ADDENDUM NO. 1
MARCH 10, 2011
SHEET ADDED

STATE OF MARYLAND
DEPARTMENT OF TRANSPORTATION
STATE HIGHWAY ADMINISTRATION
OFFICE OF TRAFFIC & SAFETY
TRAFFIC ENGINEERING DESIGN DIVISION
MD 542 (Loch Raven Blvd) and Goucher Boulevard
Loch Raven, MD

APPROVALS		REVISIONS		TRAFFIC SIGNALIZATION PLAN	
TEAM LEADER		①	UPGRADED TO VIDEO DETECTION AND REPLACED DETECTION DUE TO RESURFACING. SHA. NO. B48695177 TIMSR J416 3/01/2011	SCALE 1" = 20'. ADVERTISED DATE 8/01/1984 CONTRACT NO. _____	
ASST. DIV. CHIEF		②	ADDED PED POLE AND SIGNAL NO. 3 FOR LEFT TURN B-785-501-485 6/07/1986	DESIGNED BY B. Thompson COUNTY Baltimore	
DIVISION CHIEF		③	CHANGED DETECTOR TO DELAY OUTPUT 4/05/1986	DRAWN BY B. Thompson LOGMILE _____	
OFFICE DIRECTOR				CHECKED BY D. Doda TMS NO. _____	
				F.A.P. NO. _____ TOD NO. _____	
				TS NO. 2009C	DRAWING TSP-2 OF 5 SHEET NO. 252B OF 301

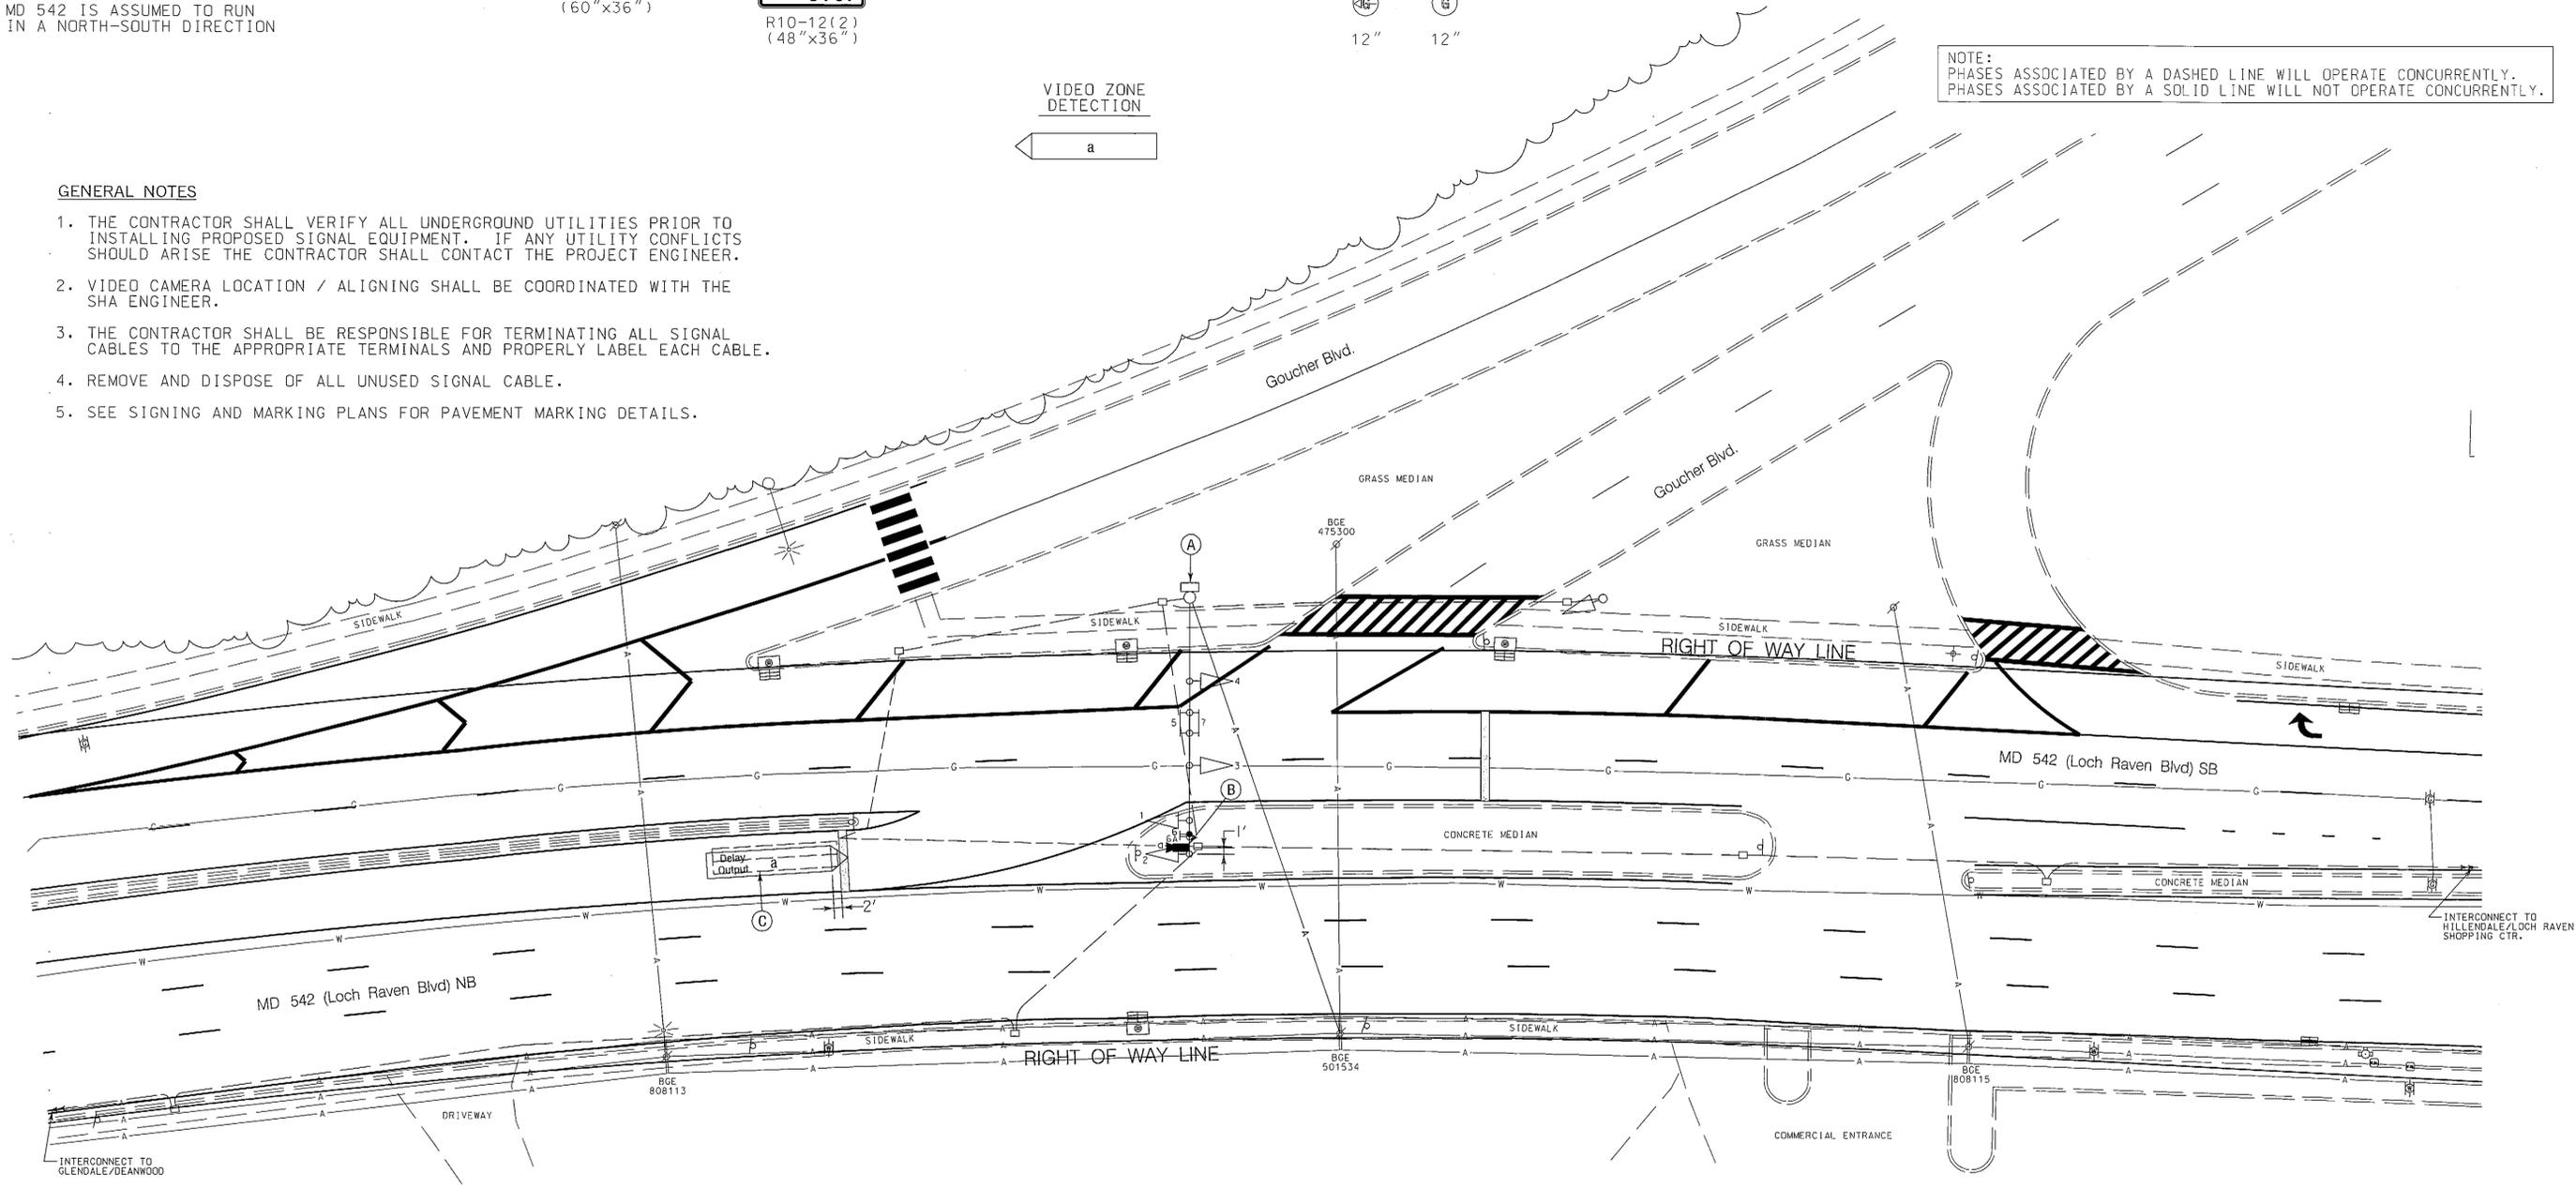
- A. USE EXISTING POLE MOUNTED CABINET AND CONTROLLER. (NOTE: SHA FORCES SHALL RETROFIT CONTROLLER EQUIPMENT TO OPERATE VIDEO DETECTION EQUIPMENT).
- B. USE EXISTING MAST ARM. INSTALL NEW OVERHEAD VIDEO DETECTION CAMERA ON MAST ARM, REMOVE EXSTING SIGN AND INSTALL R10-12(2) SIGN AS SHOWN.
- C. ABANDON EXISTING LOOP DETECTOR. DISCONNECT AND REMOVE LOOP DETECTOR CABLES FROM CONDUITS, HANDHOLES, SIGNAL STRUCTURES AND CONTROLLER.
